ADDENDUM NO. 1

DATED: SEPTEMBER 15, 2026

PROJECT: **REBID**
New Fleet Management Building for AIDT
Montgomery, Alabama

PH&J No: 2502-CUA

TITLE:	CLASS I PRECAST CONCRETE MANHOLE	DRAWING NO.:	300
DESIGNED:	TL	DATE:	09/00
CHECKED:	HR	REVISED:	01/13
		SCALE:	NOT TO SCALE

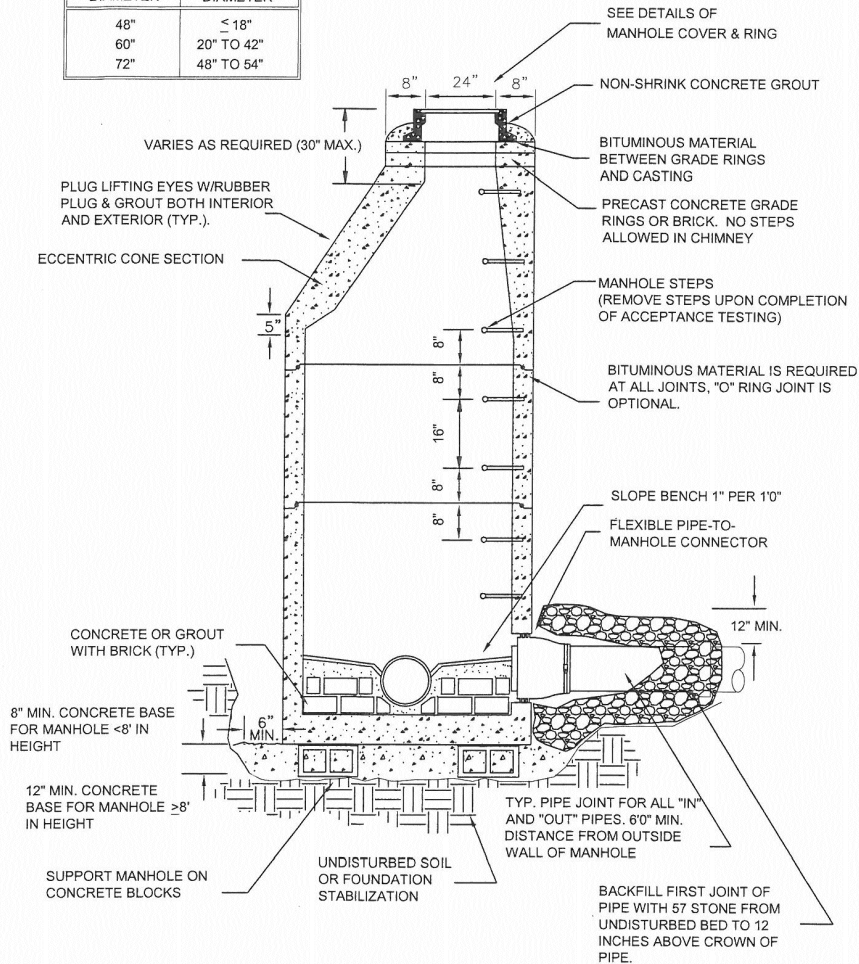
1. **Parking Lot Striping** (Sht. C1.0): See **Attachment #1** for additional parking lot striping.
2. **Sewer Lateral to Existing Manhole** (Sht. C4.0): See **Attachment #2** for manhole tap.
3. **3" Conduit with 1 ½" PEX** (Sht. P2.1): Adjust location eastward and provide addition sleeve from Bay #110 to Storage #111. See **Attachment #3**.
4. **Additional Wall Hydrants** (Sht. P3.1): Add additional wall hydrants to west end wall. See **Attachment #4**.
5. **Addition Site Power Receptacle** (Sht. E1.1): Add additional power to South-West end of parking area. See **Attachment #5**.

RE-BID
E2.1

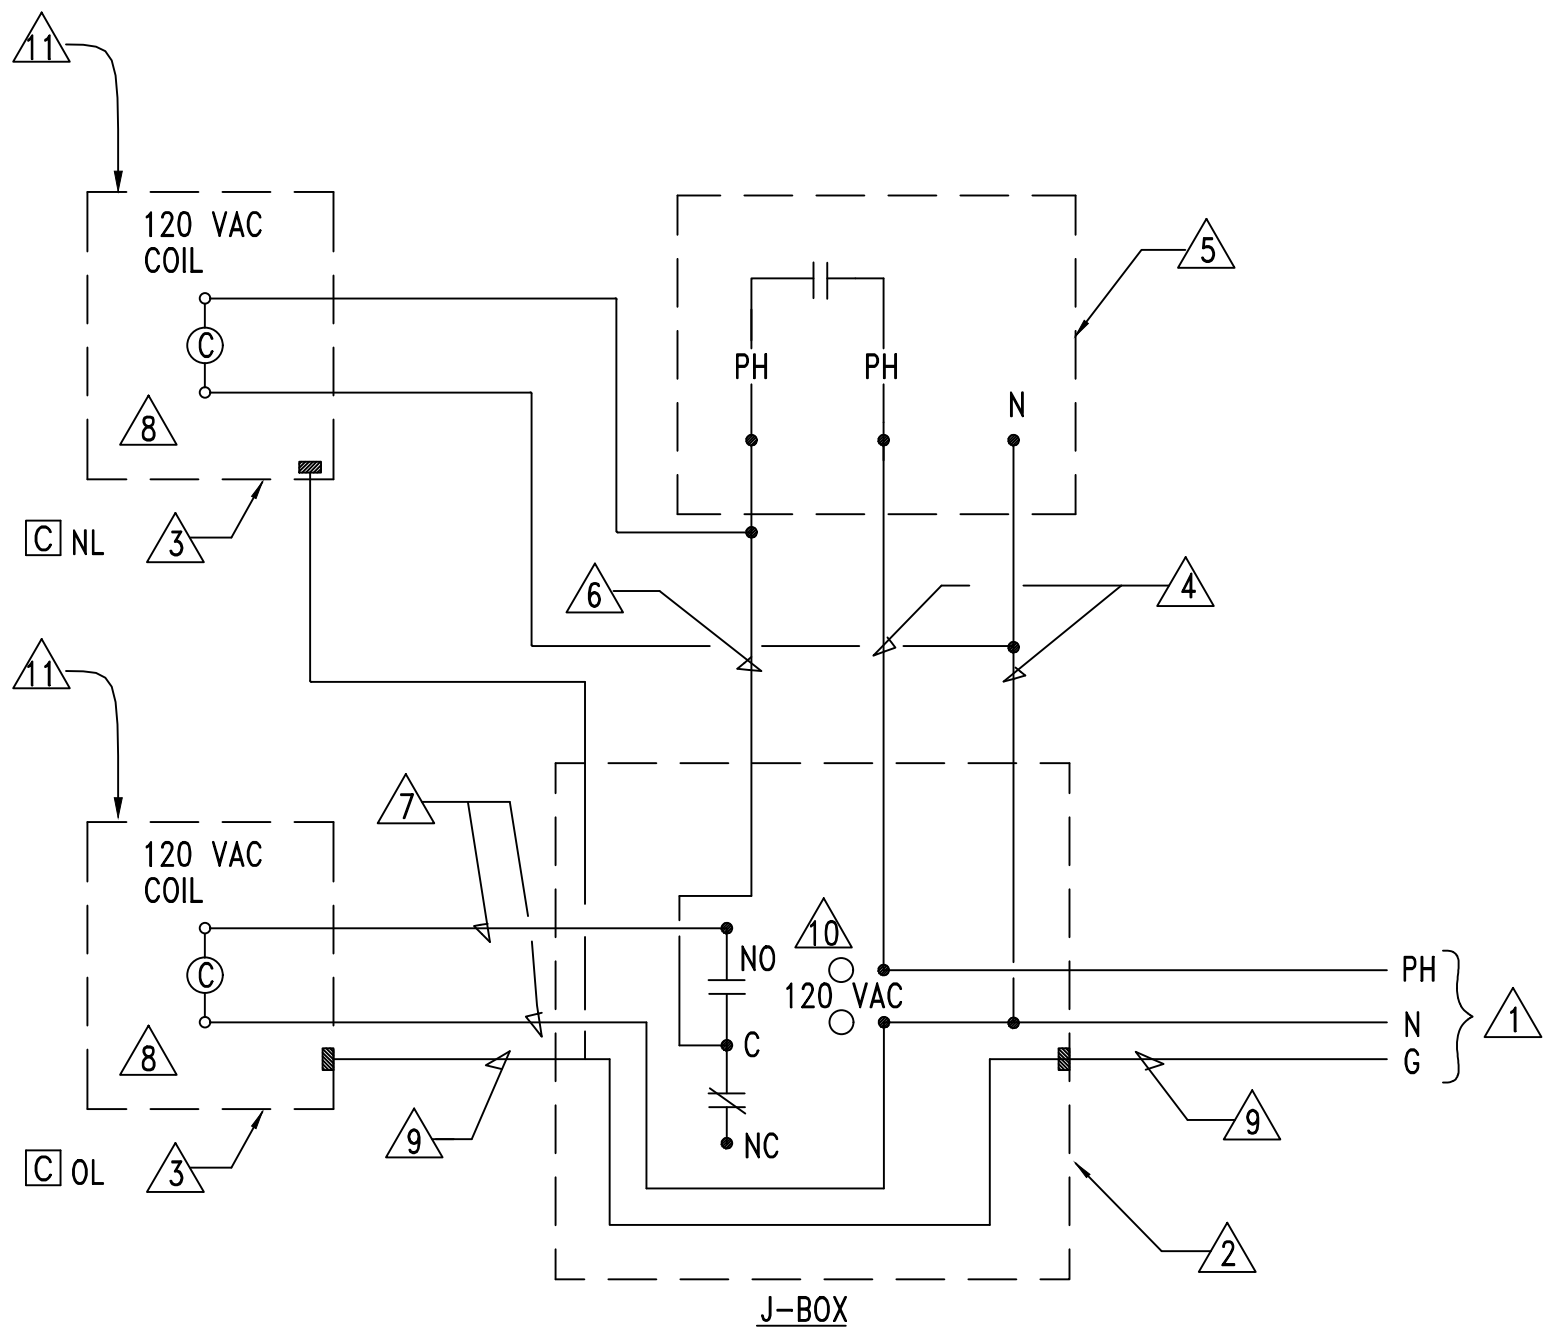
6. **Lighting of Future Office Area under Base Bid** (Sht. E2.1): See **Attachment #6**.
7. **Power of Future Office Area under Base Bid** (Sht. E3.1): See **Attachment #7** for power and shop bays for deletion of four (4) power reels.
8. **Additional EUH-1 for Future Office Area** (Sht. E3.2): See **Attachment #8** for undeveloped area heating under Base Bid.
9. **Location of IDF-1 under Base Bid** (E4.1): See **Attachment #9** for additional Sheet Notes and Plan Notes.
10. **Lighting Fixture Schedule** (Sht. E5.1): See **Attachment #10** for additional scheduled fixture.
11. **Power Riser Diagram** (Sht. E7.1): See **Attachment #11** for deletion of sheet Note #2 shown on Panel "RP1".

RE-BID
E5.1

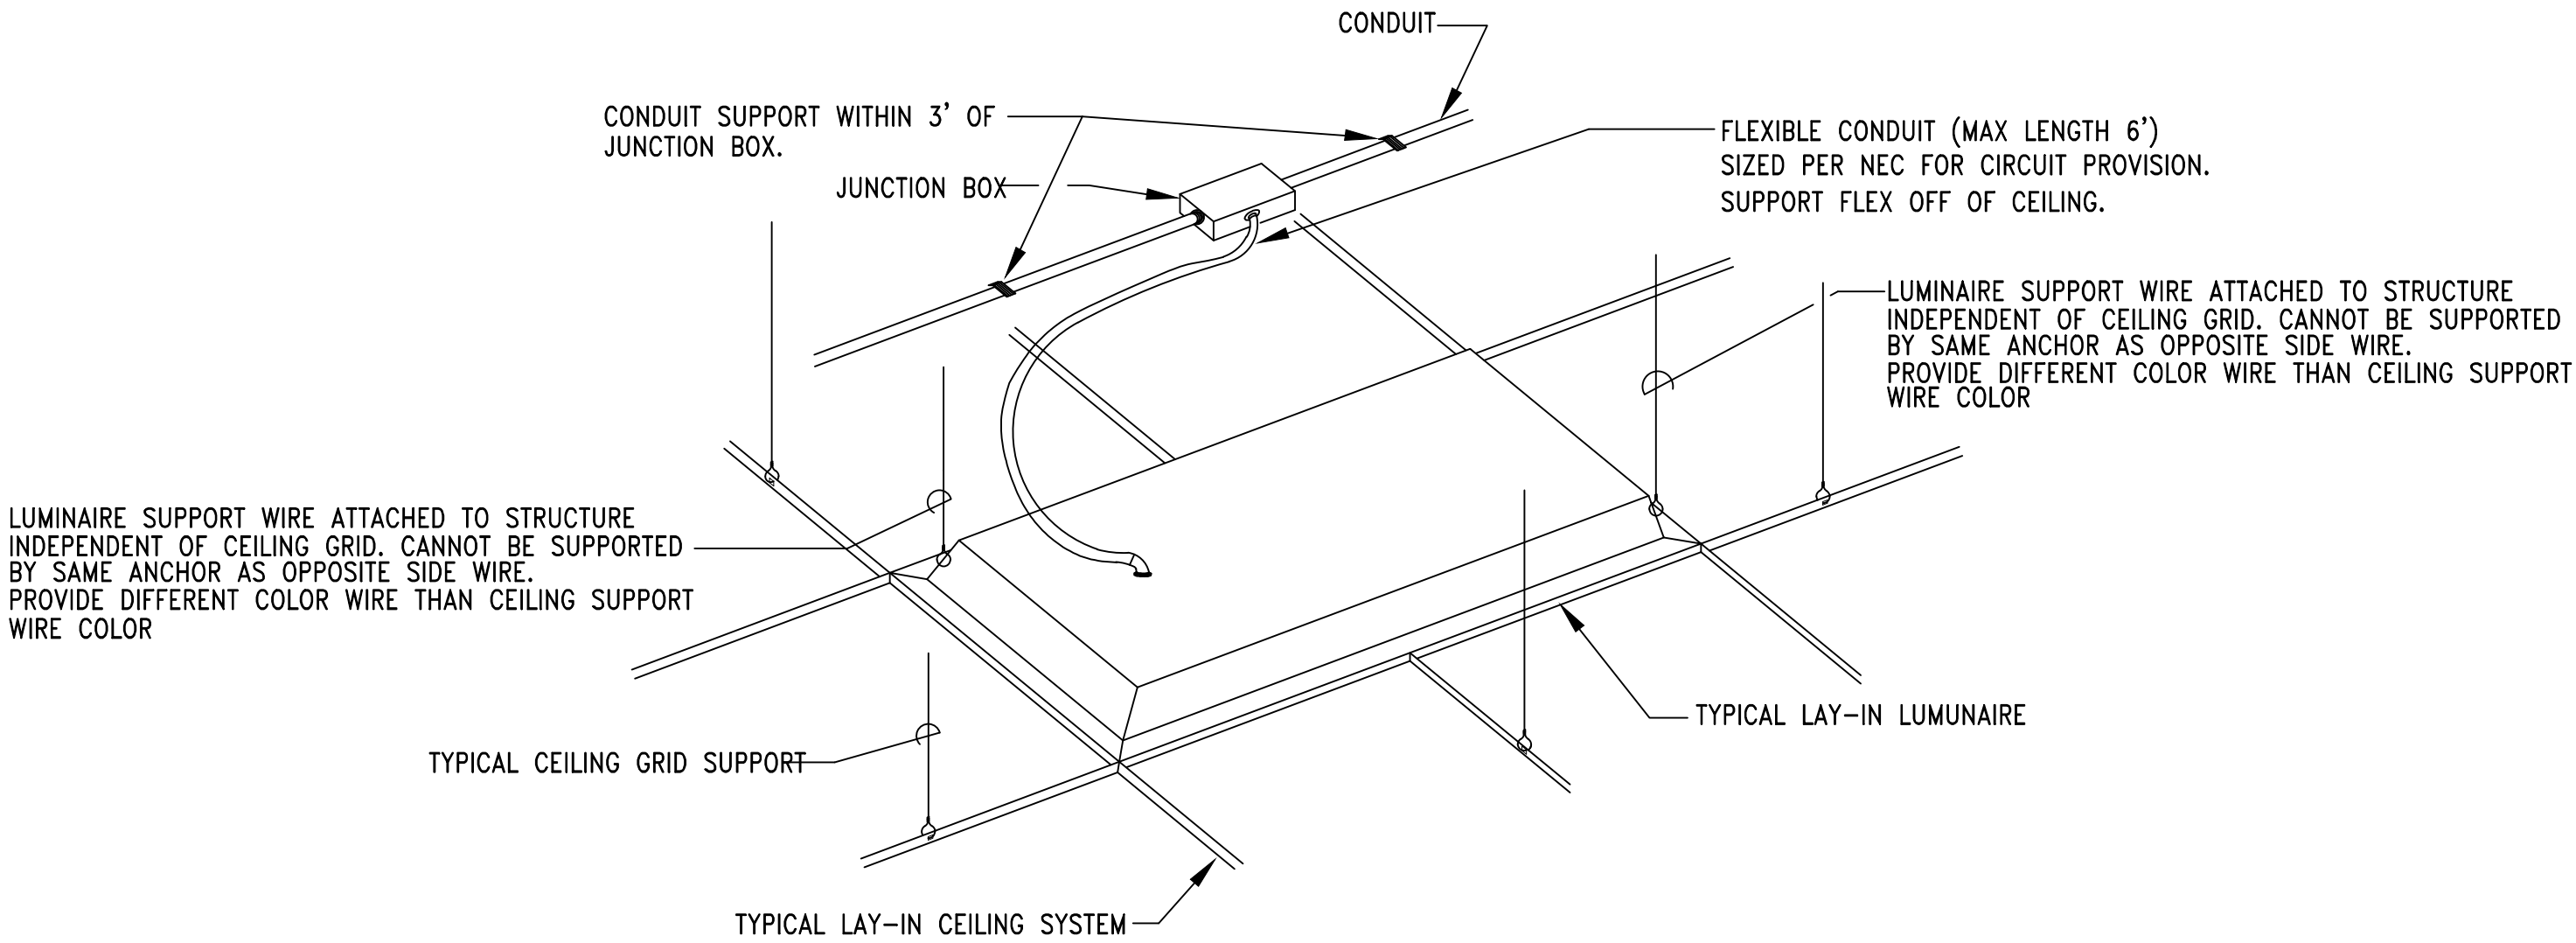
Attachment #1 – Parking Lot Striping
Attachment #2 – Sewer Lateral to Existing Manhole
Attachment #3 – 3" Conduit with 1 ½" PEX
Attachment #4 – Additional Wall Hydrants.
Attachment #5 – Additional Site Power
Attachment #6 – Future Office Area Lighting Under Base Bid
Attachment #7 – Future Office Area Power (Under Base Bid) and partial Power Reel
Deletion from contract
Attachment #8 – Future Office Area Base Bid Heating
Attachment #9 – Relocation of IDF-1 under Base Bid
Attachment #10 – Additional Lighting Fixture to Schedule
Attachment 11 – Modified Power Riser Diagram
